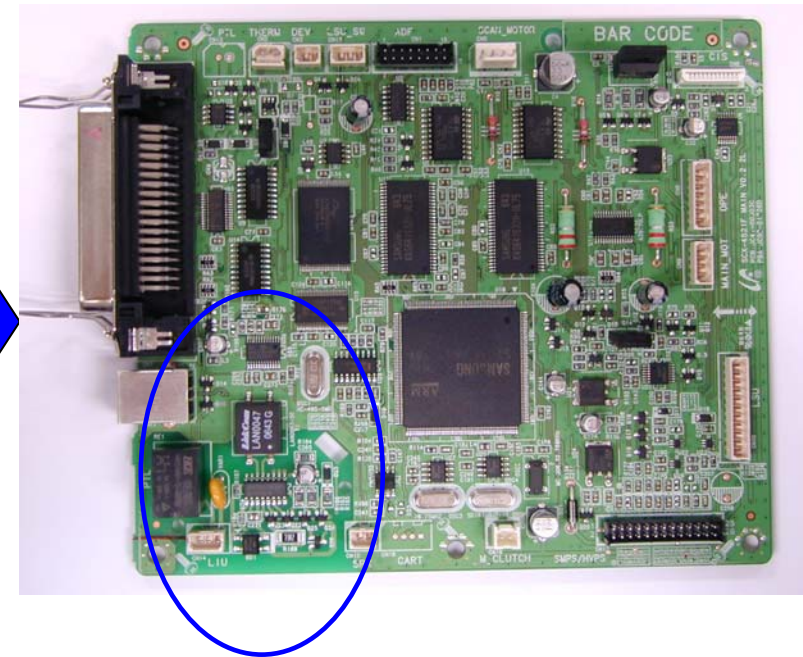
Before	After
PBA Code	JC92-01726A/B/C	JC92-01726D/E/F
Modem chip	FM336 Modem chip (1205-001896)	Silab Modem chip (1205-002852) Silab DAA chip (1205-002500)
Other components for LIU		Some component move from LIU PBA to Main PBA in the blue circle.

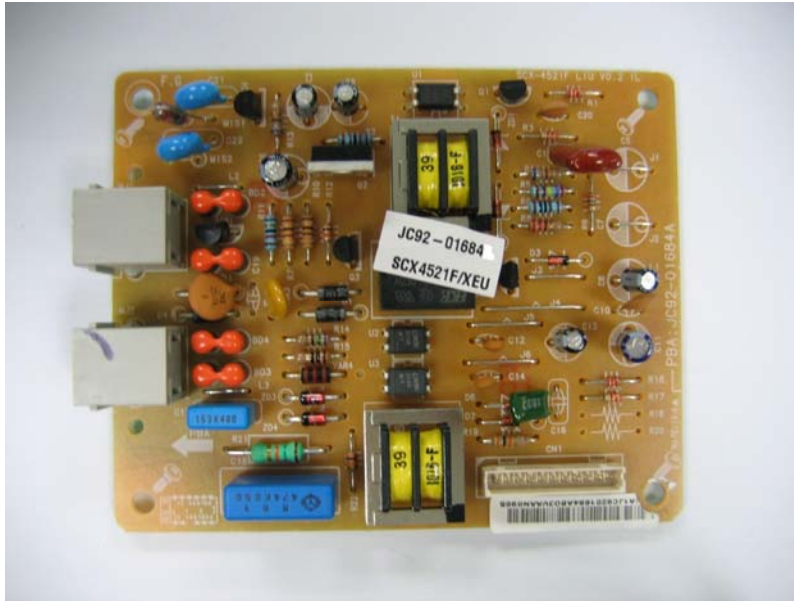
Before	After
PBA Code	JC92-01684A/B/C	JC92-01684H/J
		Some components move to Main PBA and PBA get smaller.

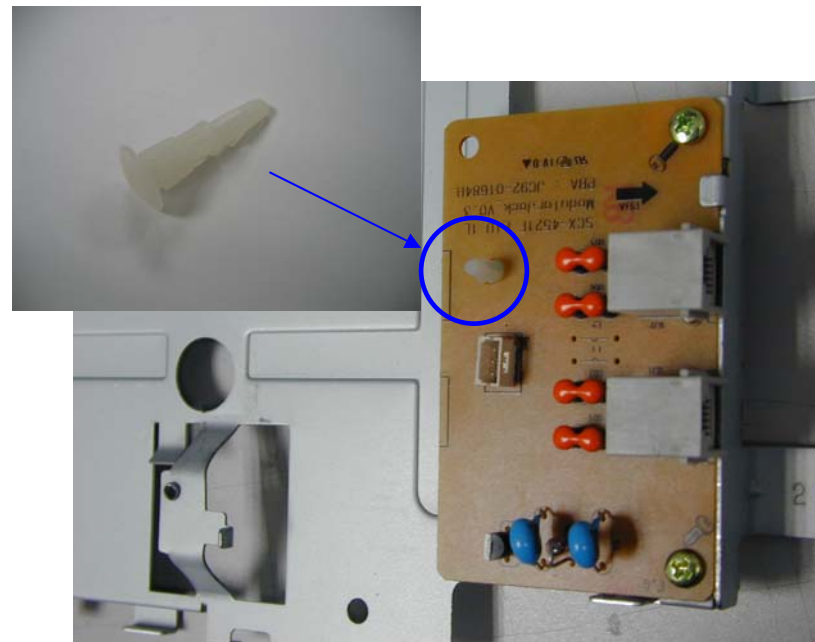
Before	After
Harness Code	JC39-00413A 11pin	JC39-00641A 3pin with 1 core

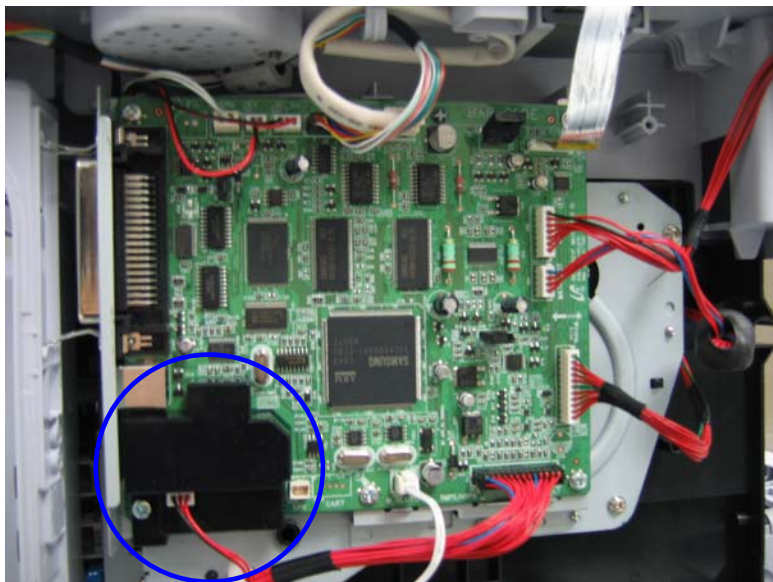
Added item	Cover-LIU	Supporter
Code	JC63-01272A	6103-000101
	It cover the LIU components on the Main PBA	It support the LIU PBA.
